# HARVEST ROAD INFRASTRUCTURE SITE PLAN

## 48TH AVENUE TO 56TH AVENUE

COVER SHEET

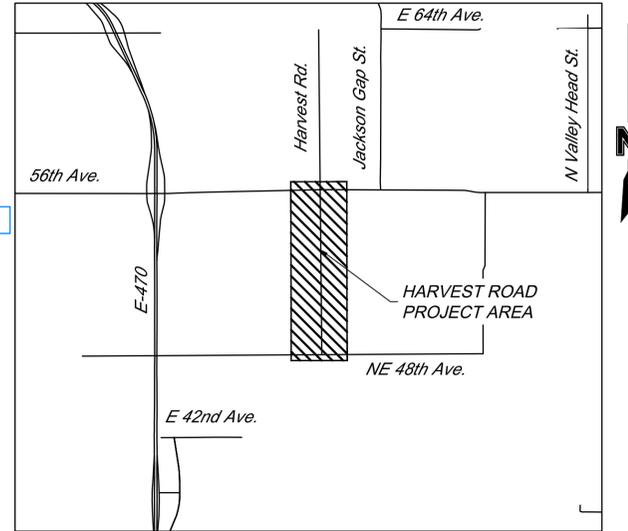
The site plan will not be approved by public works until the preliminary drainage letter/report is approved.

This site plan will not be approved until the ISP's showing required infrastructure are approved.

Advisory: Interim lighting may need to be provided prior to the decommissioning of the sanitary force main. Once the force main is decommissioned, the lighting may need to be reconfigured and reconstructed to meet lighting standards. The interim and final lighting locations are to be determined with the civil plans.

Acknowledged

Acknowledged. Note has been added

ROADWAY PLANS  
501+75 - 515+50  
HARVEST ROAD INFRASTRUCTURE SITE PLAN  
48TH AVENUE TO 56TH AVENUE  
AURORA, CO  
2022

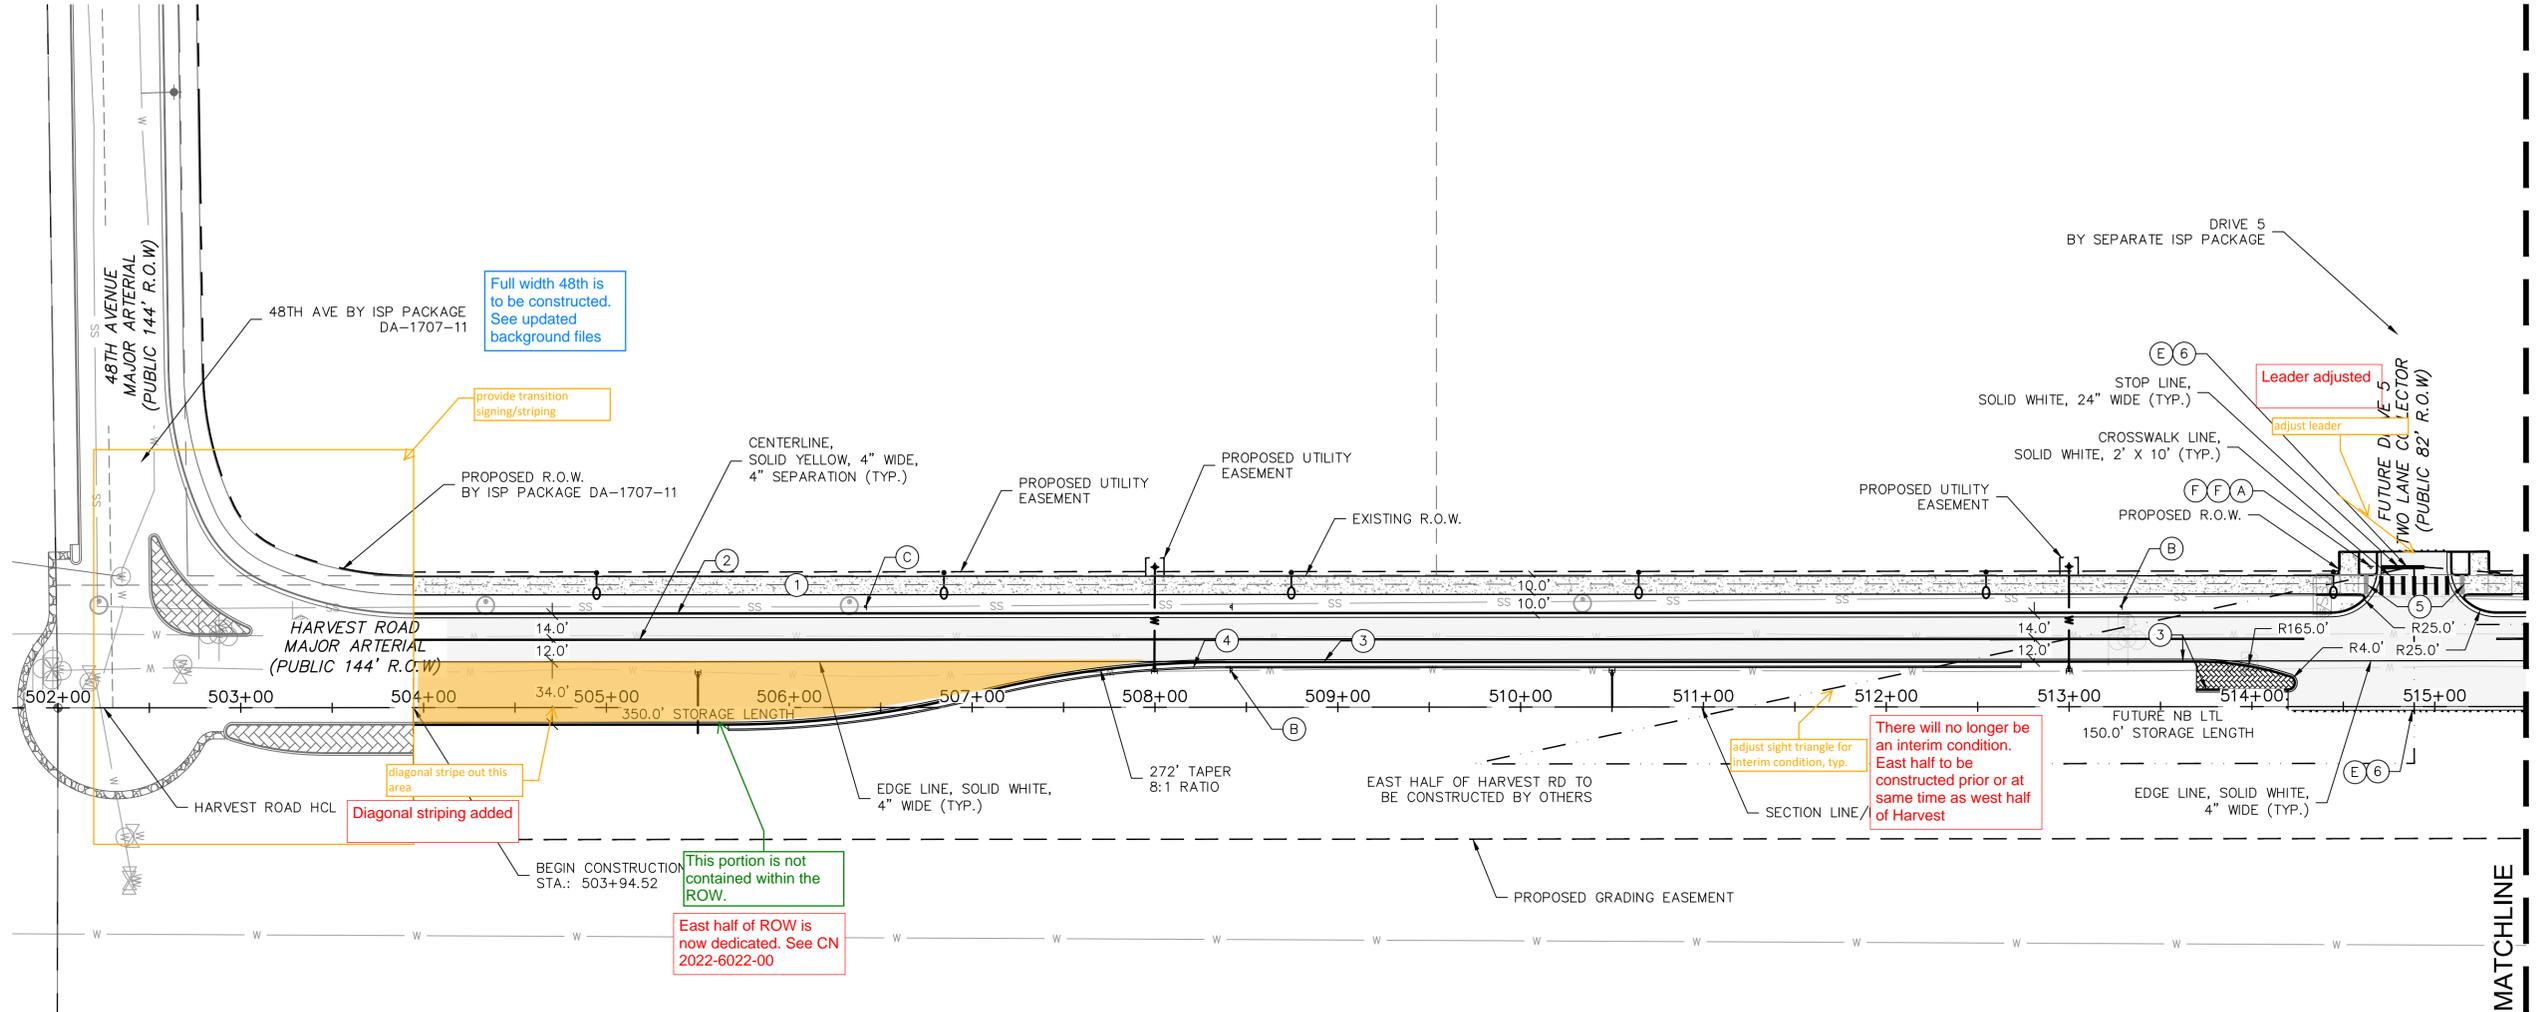
Advisory: Interim lighting may need to be provided prior to the decommissioning of the sanitary force main. Once the force main is decommissioned, the lighting may need to be reconfigured and reconstructed to meet lighting standards. The interim and final lighting locations are to be determined with the civil plans.

ROADWAY PLANS  
543+00 - 556+75

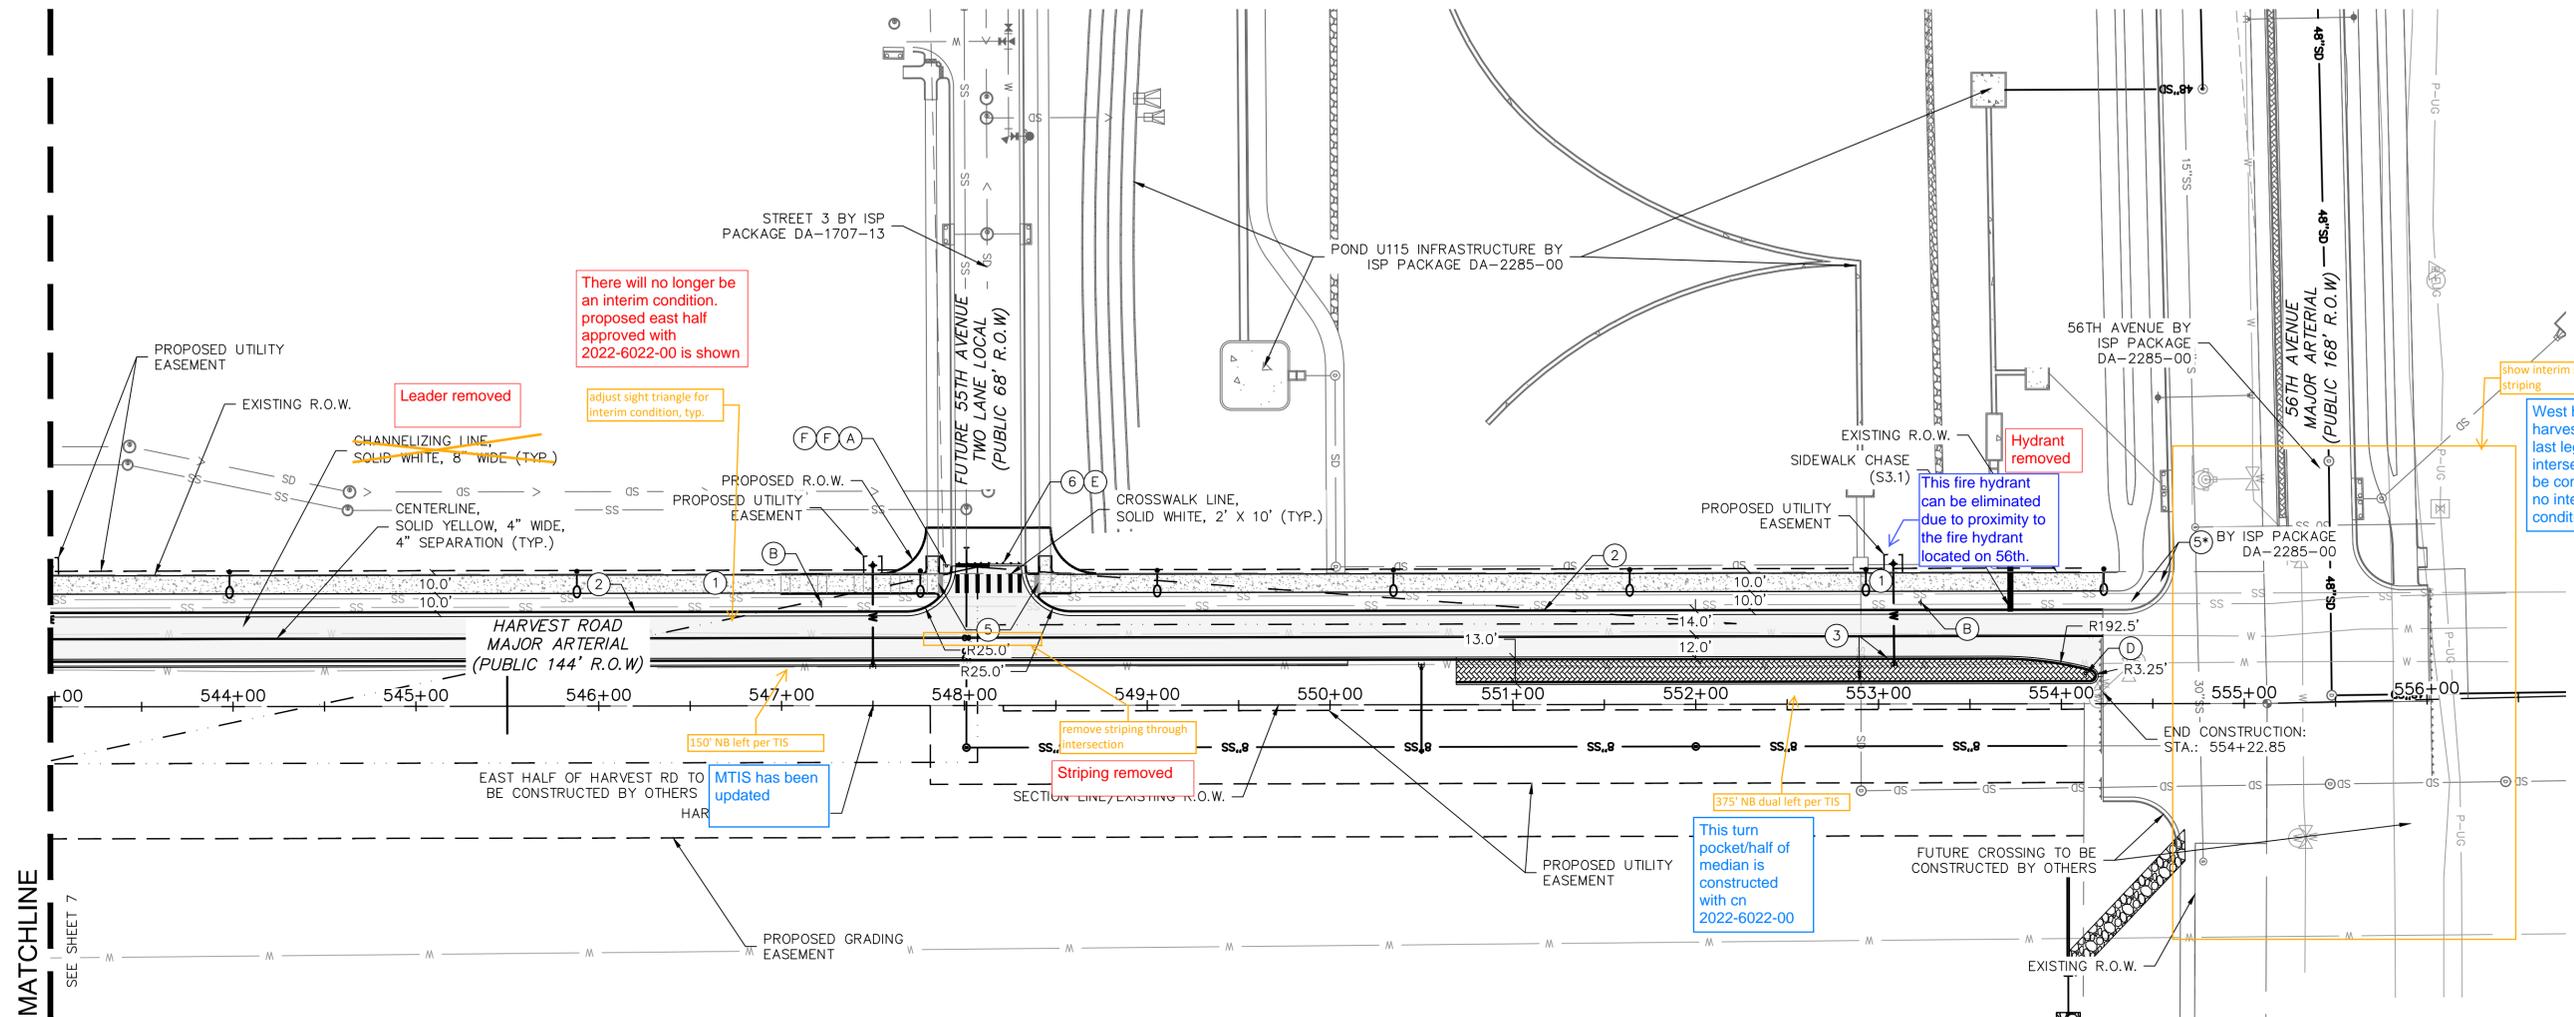
show interim signing/stripping  
West half of harvest will be last leg of intersection to be construction. no interim condition exists

150' NB left per TIS  
remove striping through intersection  
Striping removed  
MTIS has been updated

There will no longer be an interim condition. proposed east half approved with 2022-6022-00 is shown

Leader removed

GRADING & UTILITY PLANS  
515+50 - 529+25  
HARVEST ROAD INFRASTRUCTURE SITE PLAN  
48TH AVENUE TO 56TH AVENUE  
AURORA, CO

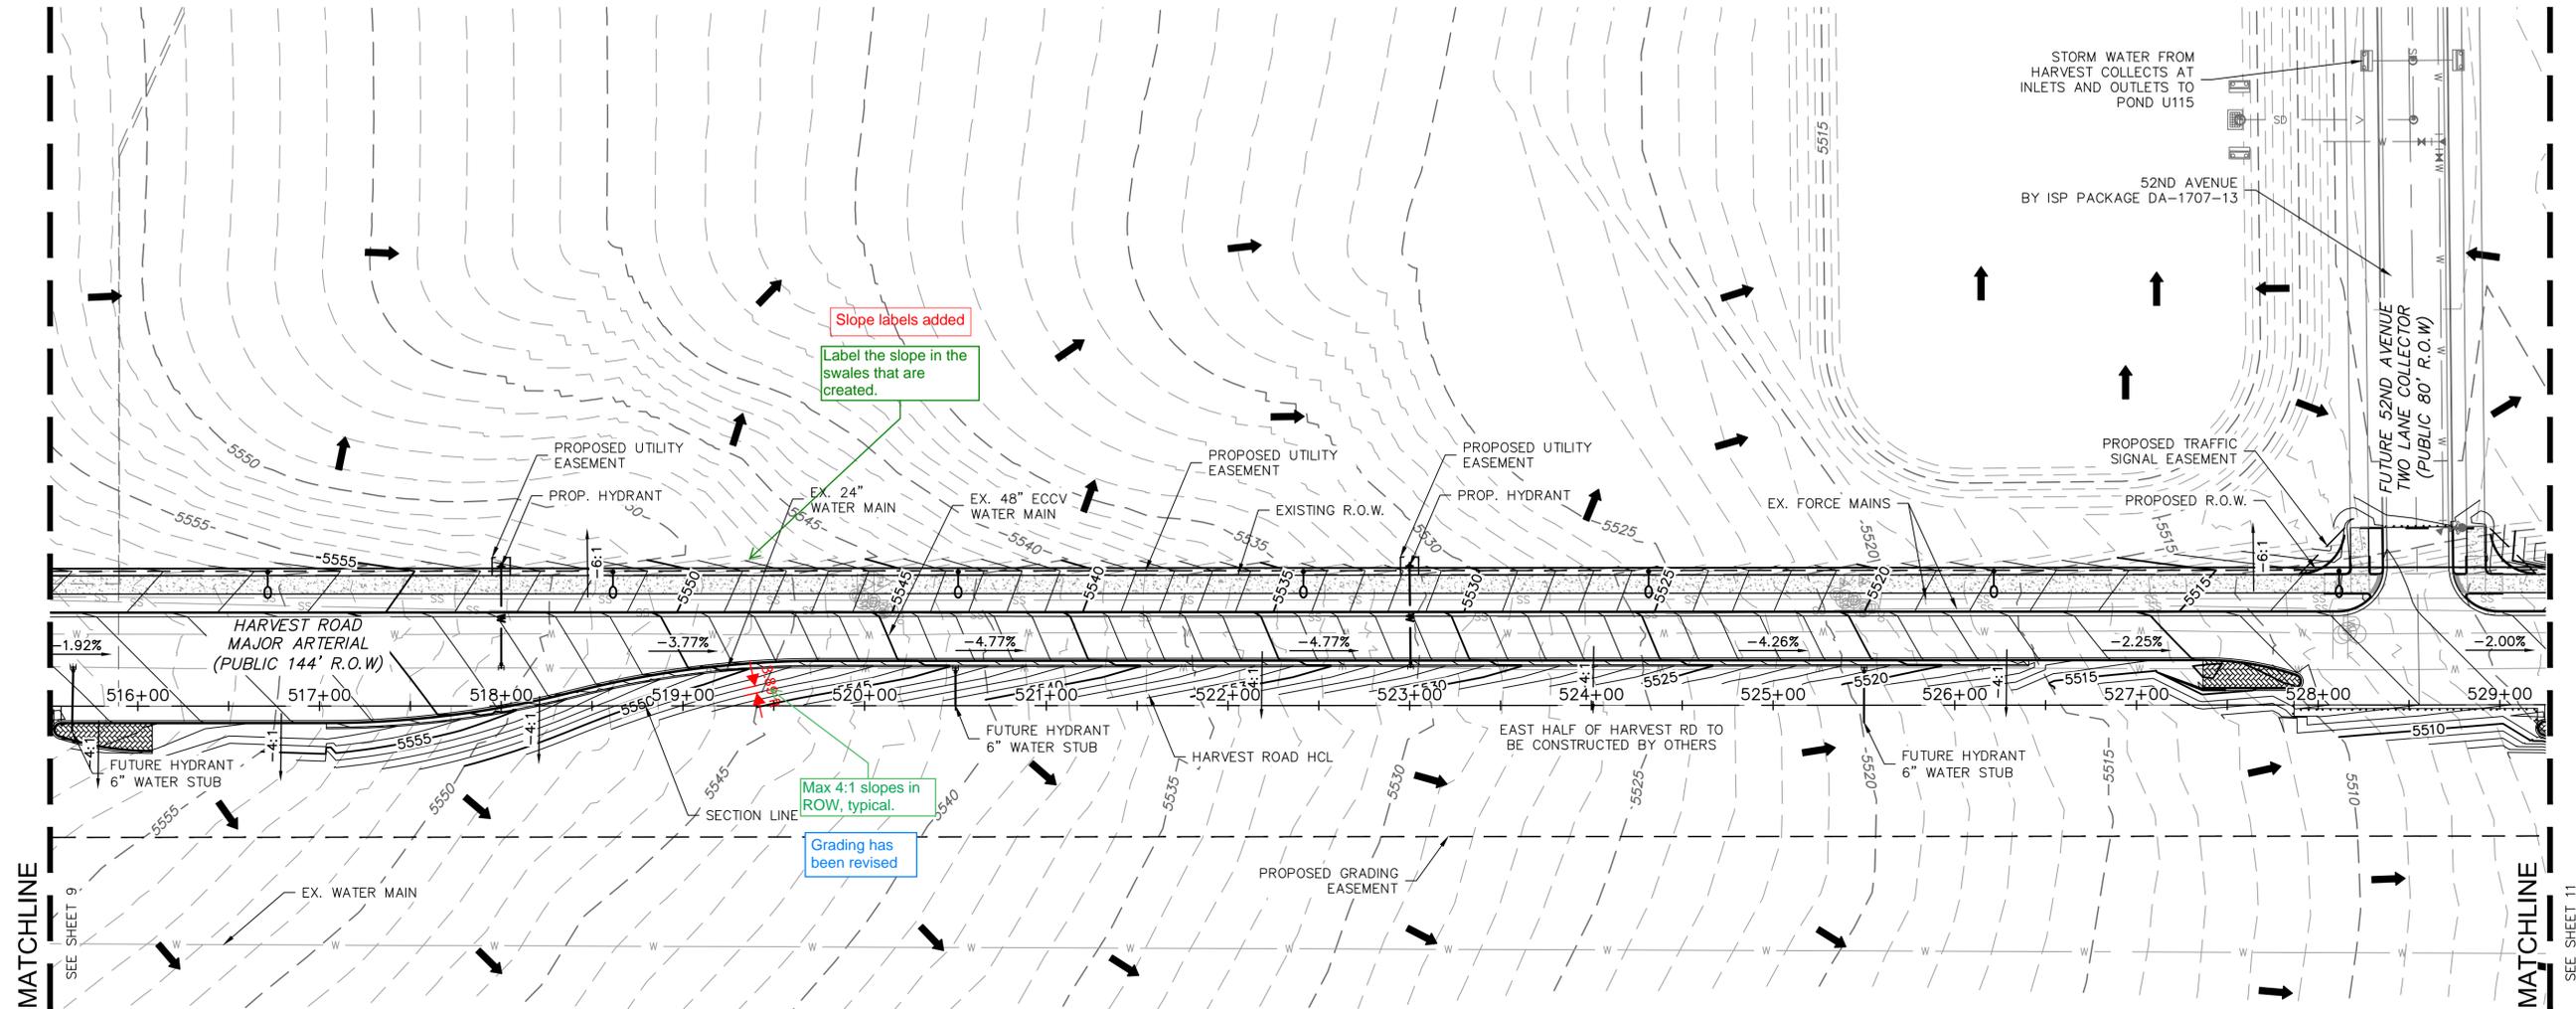
Add the following note to sheets that show swales IF the slope is less than 2%: PRIVATE TEMPORARY SWALE SHALL BE MAINTAINED BY THE DISTRICT AND THE SLOPE LESS THAN 2% PERMITTED FOR UP TO 36 MONTHS OR THE 201ST CERTIFICATE OF OCCUPANCY (50% OR 502). OTHERWISE REVISIONS SHALL BE SUBMITTED FOR CONCRETE LINING THE SWALE. IN ADDITION, THE CITY RESERVES THE RIGHT, PRIOR TO 36 MONTHS AND 201ST CO, TO REQUIRE THE SWALE TO BE CONCRETE LINED SHOULD THERE BE ISSUES WITH REDUCED CAPACITY, SEDIMENTATION, PONDING, OR OTHER ITEMS IDENTIFIED BY THE CITY ENGINEER.

Note added

LANDSCAPE PLANS  
546+00 - 551+50

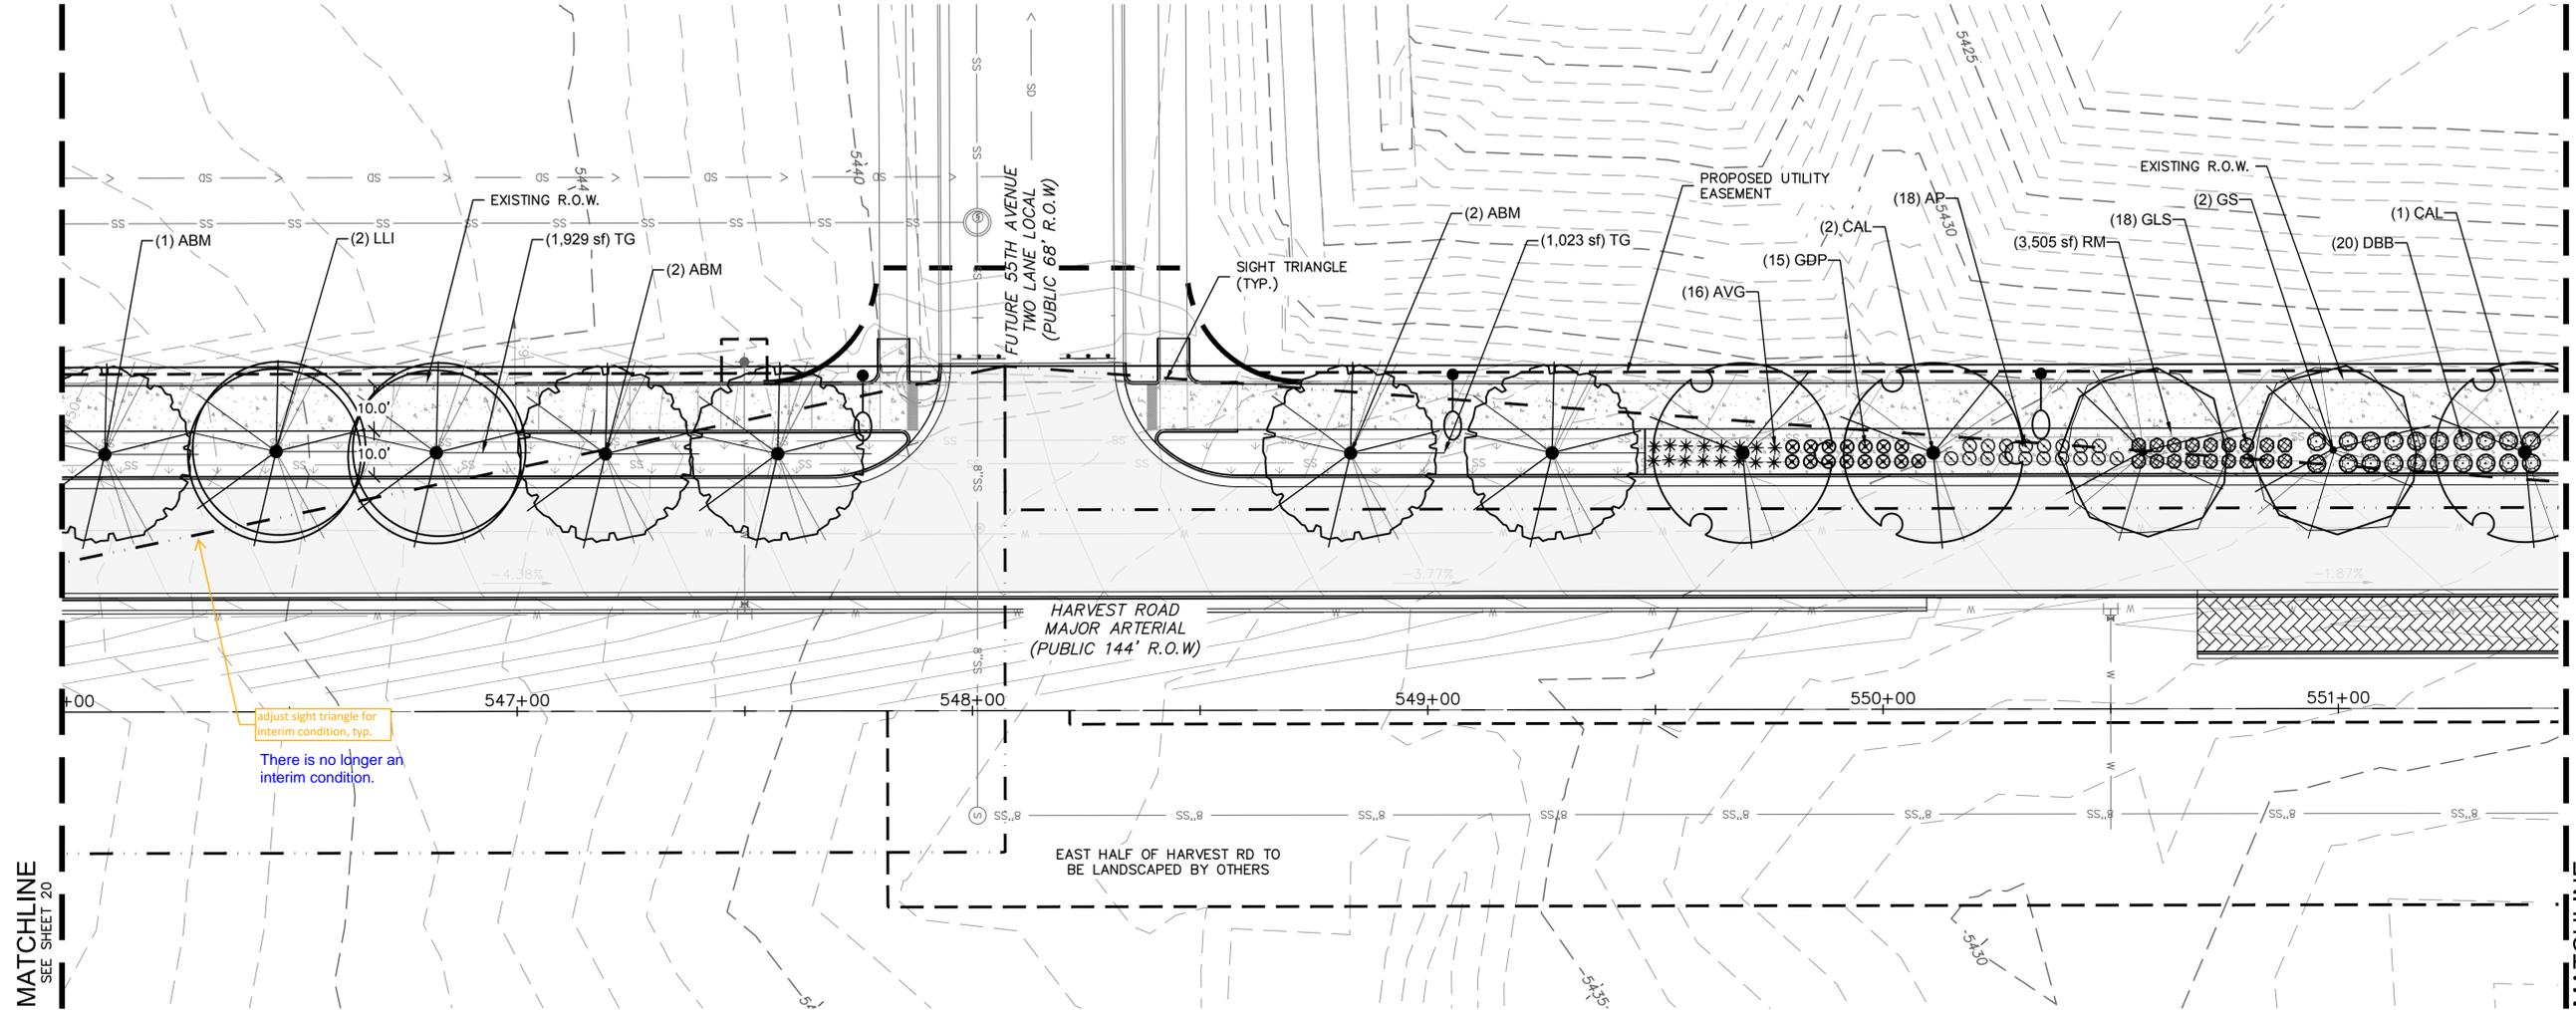
adjust sight triangle for interim condition, typ.  
There is no longer an interim condition.
